**APPLICATION FOR CERTIFICATION 07-AFC-7  
SUPPLEMENT A**

**KRCD COMMUNITY  
POWER PLANT**

Re: Supplemental Information in Response to CEC Data Adequacy Request for the Kings River Conservation District Community Power Plant Application for Certification (07-AFC-07)

**KINGS RIVER CONSERVATION DISTRICT COMMUNITY POWER PLANT  
APPLICATION FOR CERTIFICATION (07-AFC-7)  
SUPPLEMENT A**

## KRCD COMMUNITY POWER PLANT

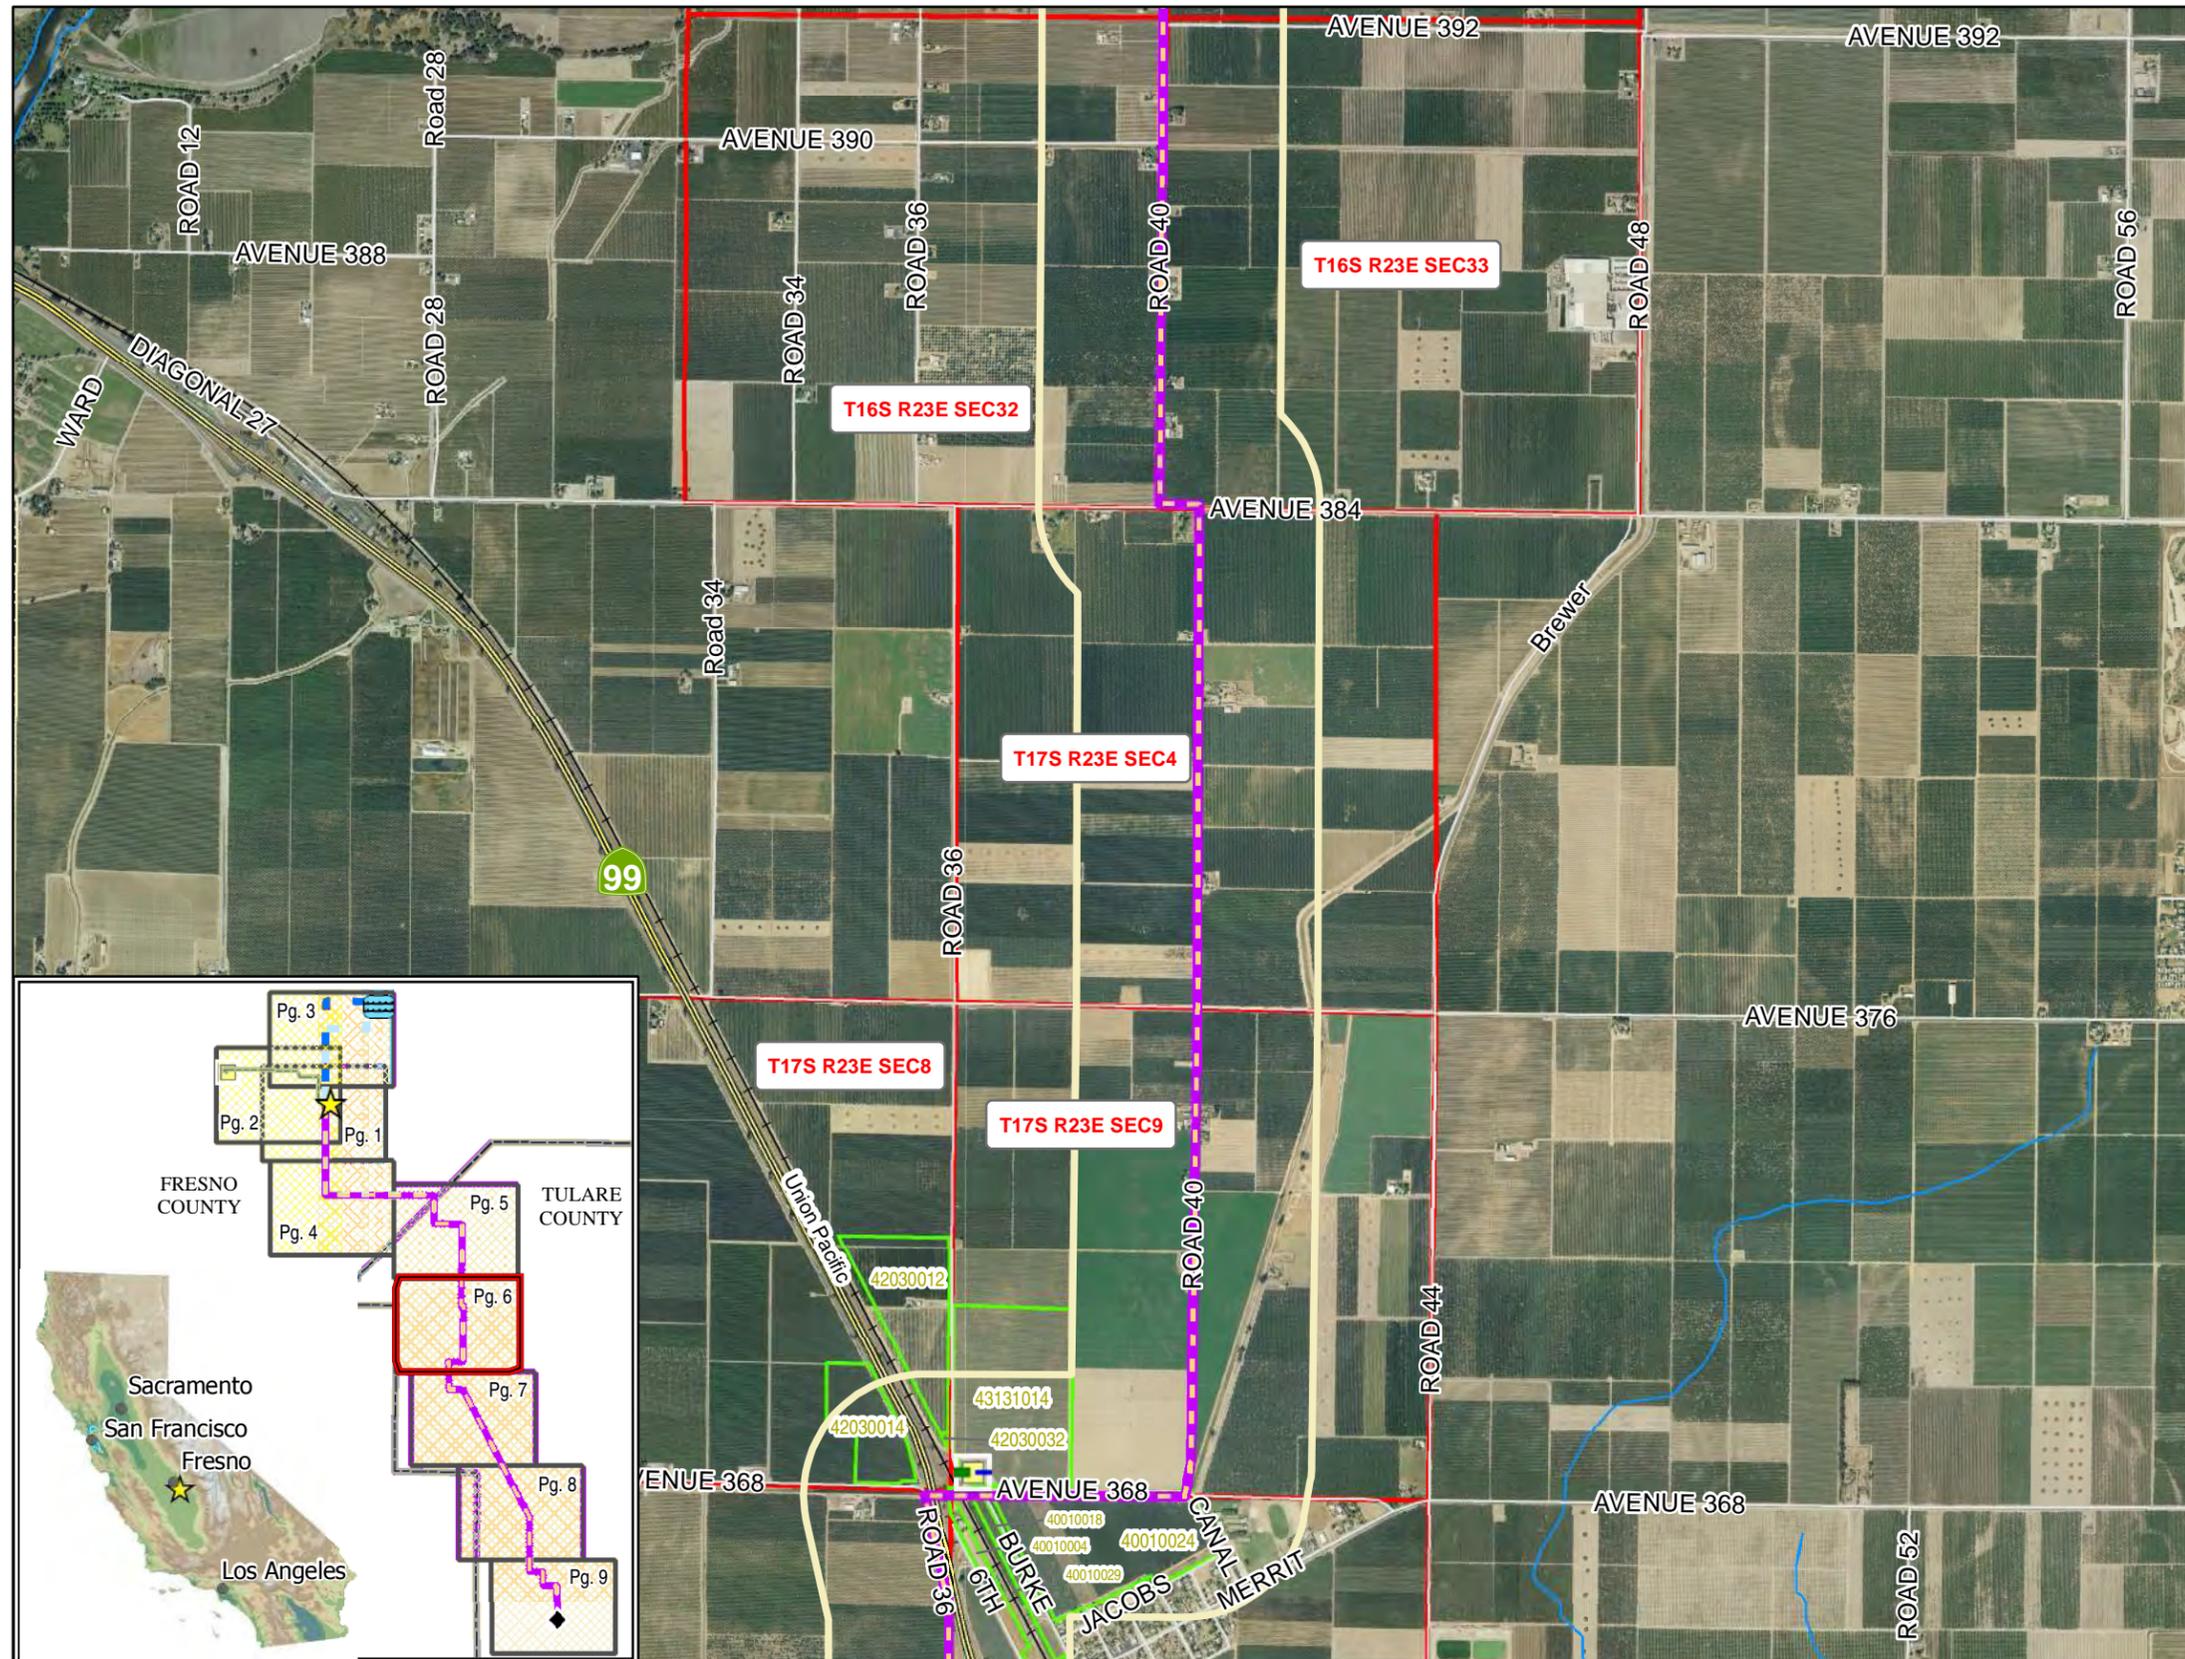
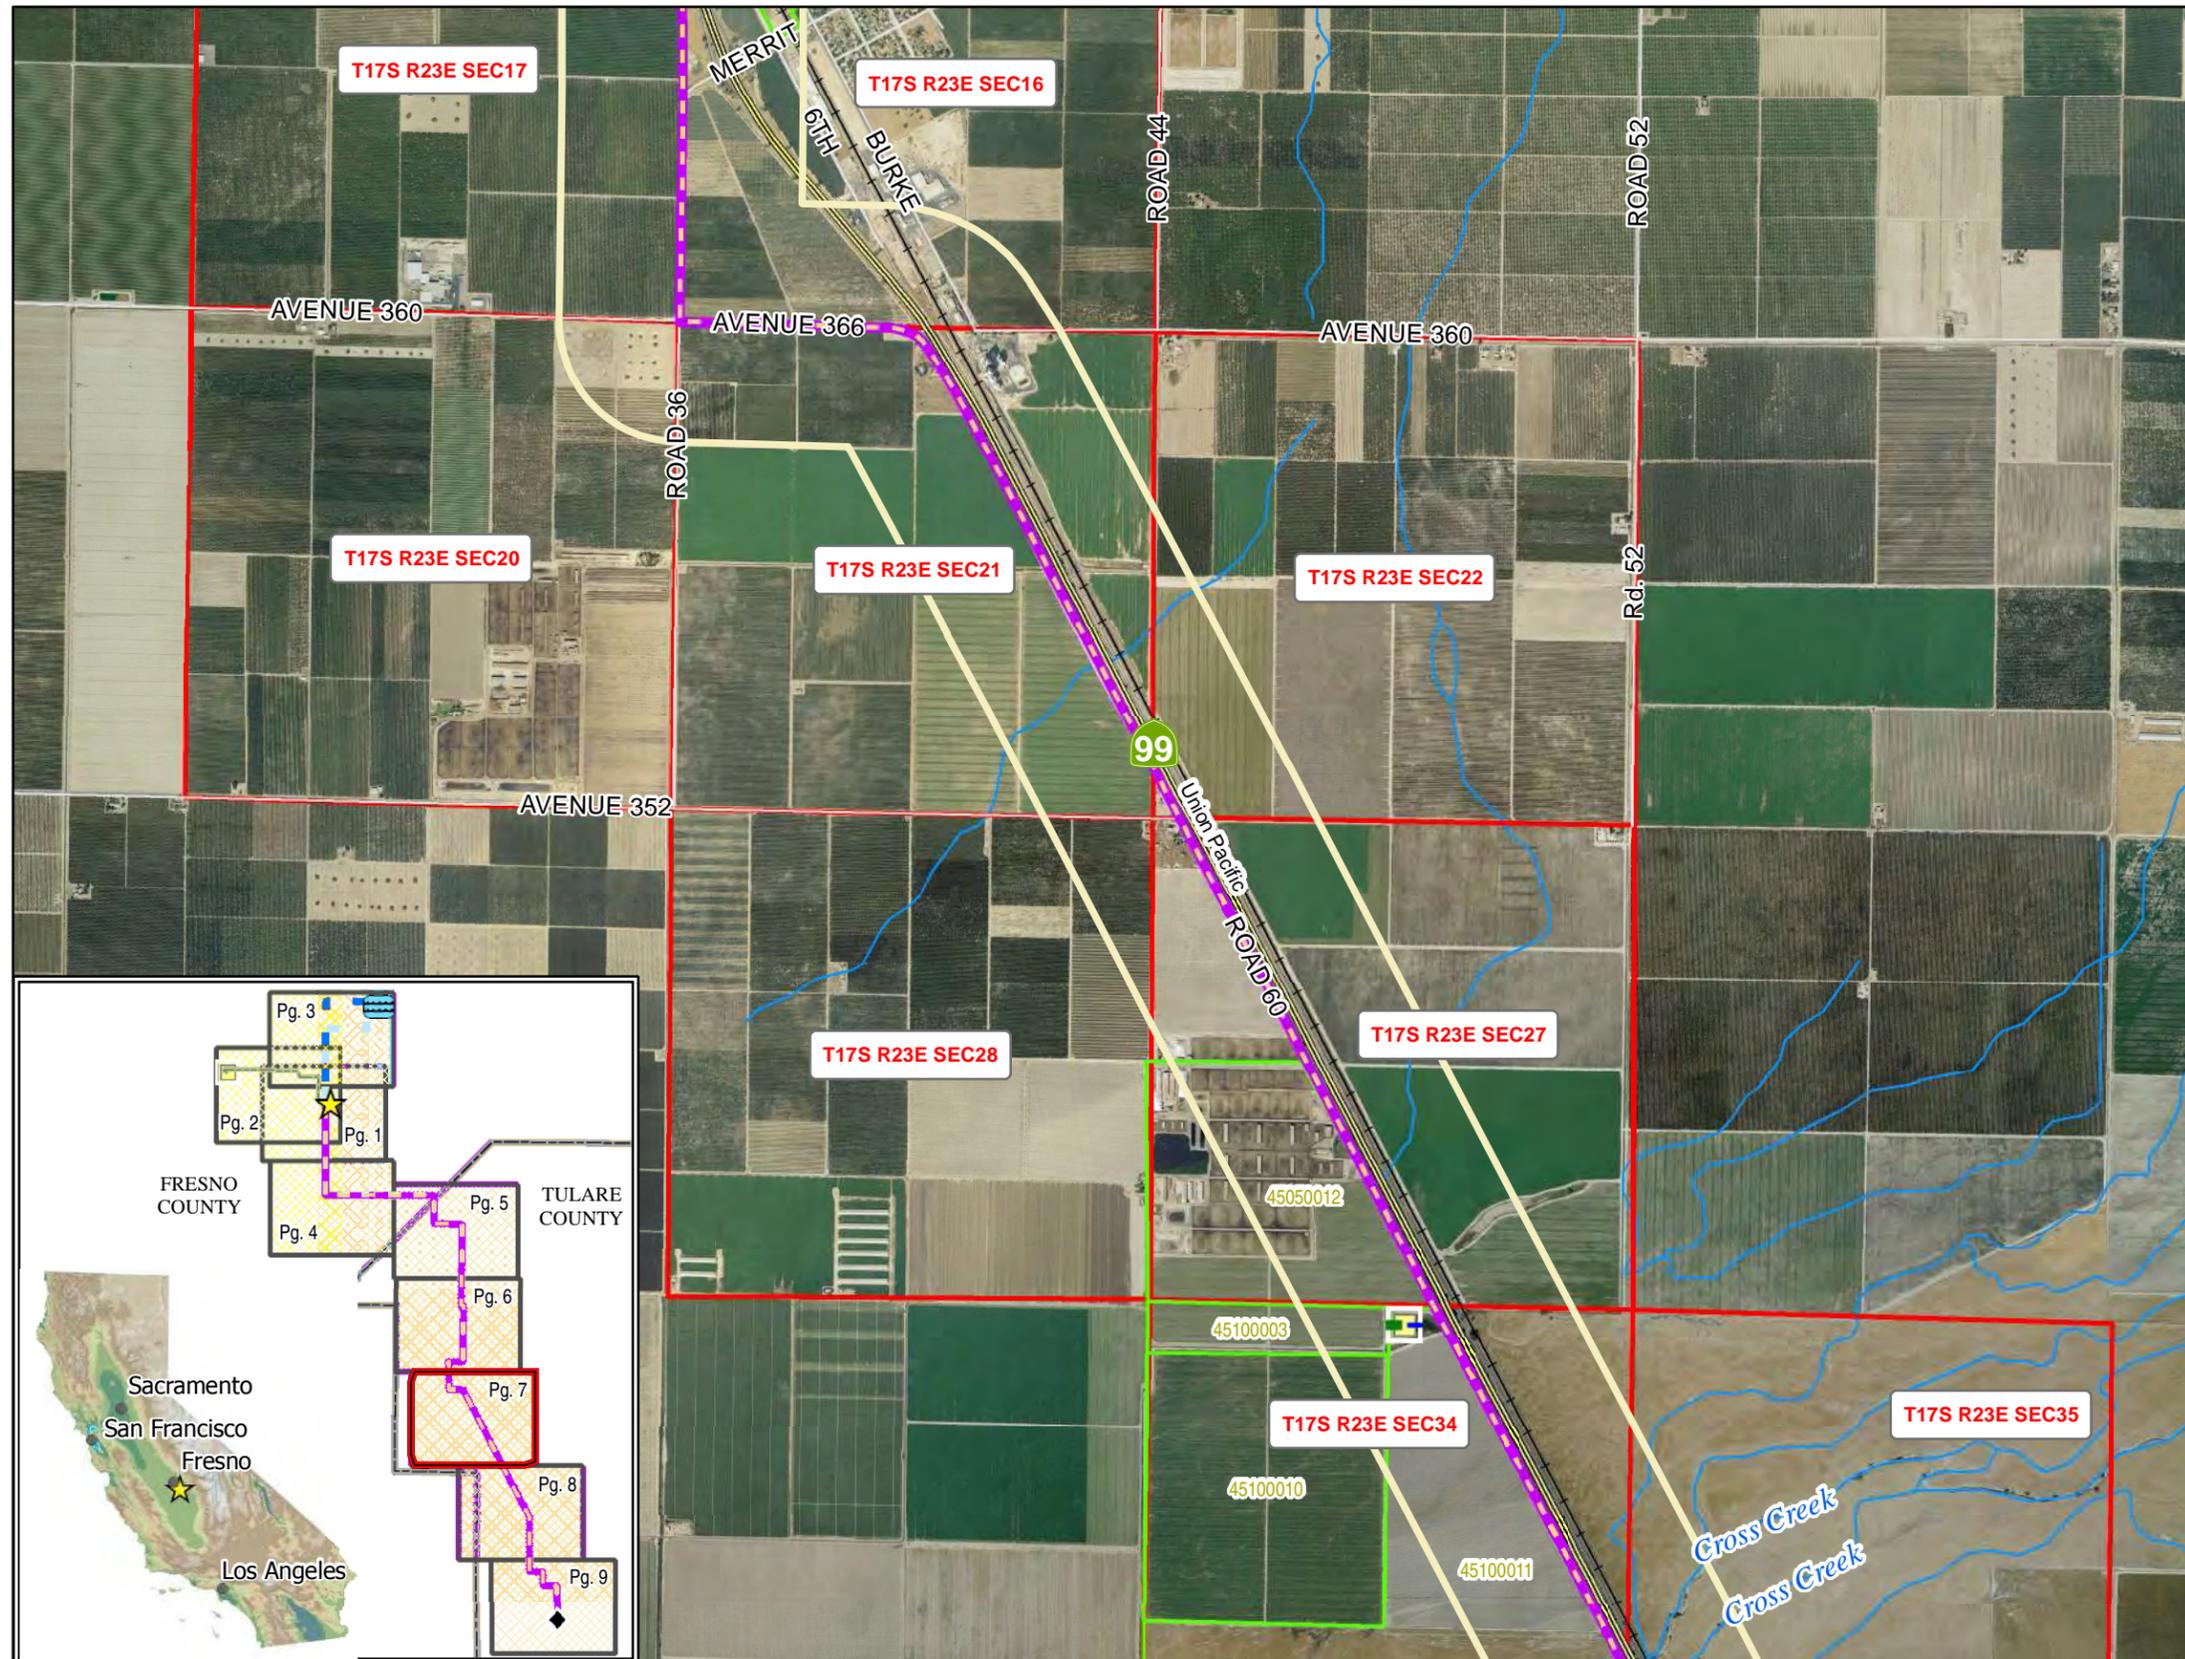
Provide the section, township, range, county, and county assessor's parcel number for the proposed water, gas, or transmission interconnection routes.

Included as Attachment PO-2, are revised Figure 1-3 - KRCD CPP Project Area and revised Figure 2-7 - KRCD CPP Site and Land Description. The revised figures include applicable section, township, and range information as well as the county assessor's parcel numbers for areas where the KRCD CPP project area crosses private property. The attached revised Figures 1-3 and 2-7 should replace Figures 1-3 and 2-7 in KRCD CPP AFC Volume 3.
